SINCE 1834		HISTORIC PRESERVATION COMMISSION Agenda Item Executive Summary					
		Agenda Item Title/Address:	COA: 1 E. Main St. (accessibility ramp)Construct accessibility ramp to rear entrance from parking lotDoug Gilbert				
		Proposal:					
		Petitioner:					
		Please check ap	propriate box	x (x)			
		PUBLIC HEARING			MEETING 7/17/13		X
AGE	NDA ITEM	CATEGORY:					
Х	Certificate o	of Appropriateness	(COA)	F	Façade Improvement Plan		
	Preliminary	Review		I	Landmark/District Designation		
	Discussion 1	ltem		(Commission Business		
ATT	ACHMENT	S:		I			
Revi	sed railing des	sign					
Phote	os of existing	railings					
Plans	s for proposed	l ramp					
EXE	CUTIVE SU	MMARY:					
The	Commission r	eviewed and table	d this COA on	6/19/13

BMO Harris Bank is proposing to install an accessibility ramp from their rear parking lot up to the rear/south facing entrance to the building. The location is currently a mulched area.

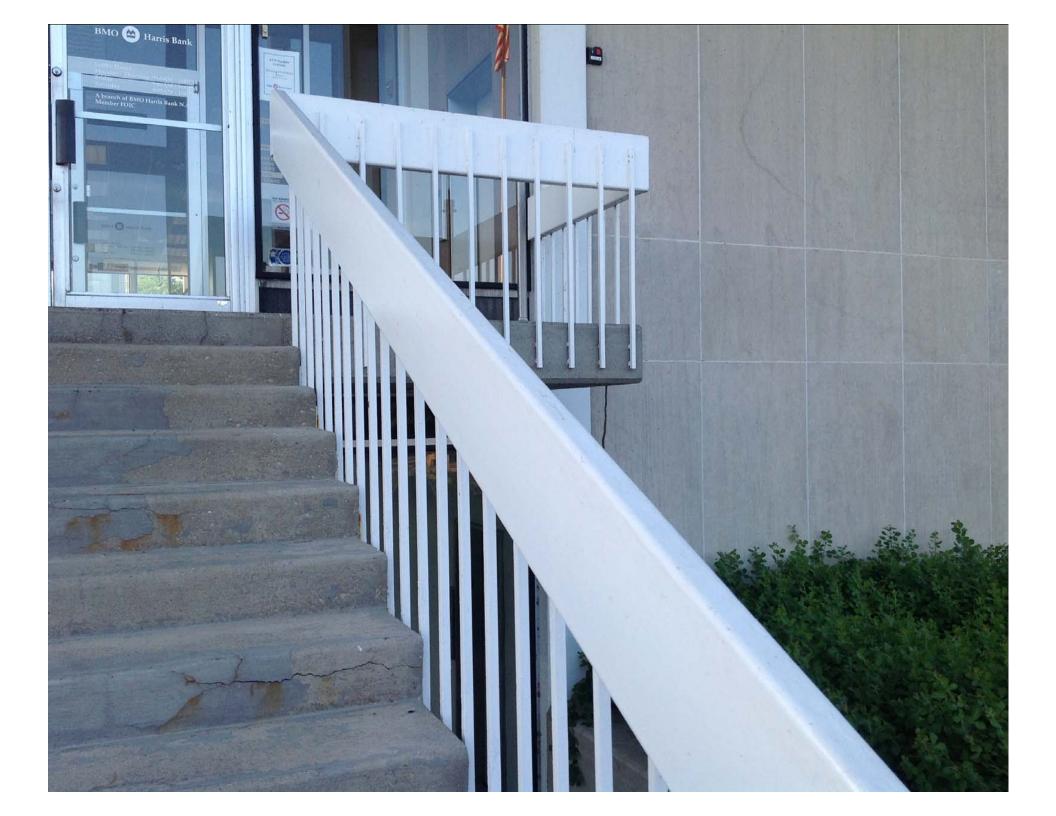
The Commission supported the proposal but requested the railing design be revised to more closely match the existing railing design on the building. A revised railing design is attached.
